# Seattle Design Commission

**Minutes of the Meeting  
19 October 2006**

## **Projects Reviewed**

DPD Planning Updates  
Woodland Park Zoo West Garage  
Hancock Fabrics/Fauntleroy Place  
Greenwood Ave North Improvements

**PUBLIC OPEN SPACE,  
LANDSCAPE & AMENITIES**

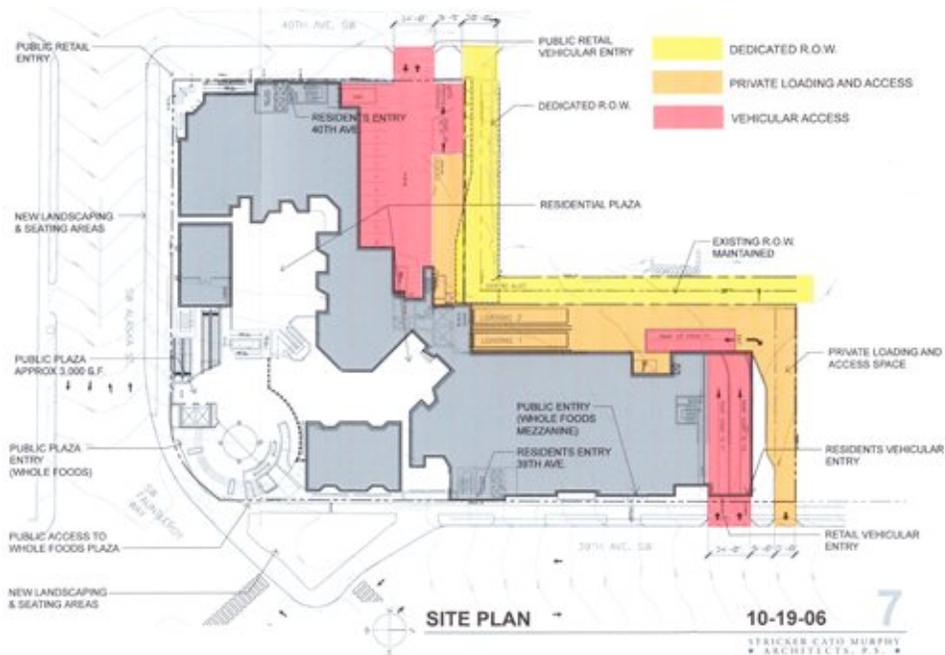
- **Regarding the public benefits, the Commission appreciates improvements to the existing triangular open space with landscaping amenities, but questions the upper level open space as a public space, noting that its location is more beneficial to residents and businesses than general pedestrians.**

- **The Commission suggests enlarging the lower level public space, investing in art pieces for that space and looking around for more ground level areas on site for pedestrian-oriented public benefits.**
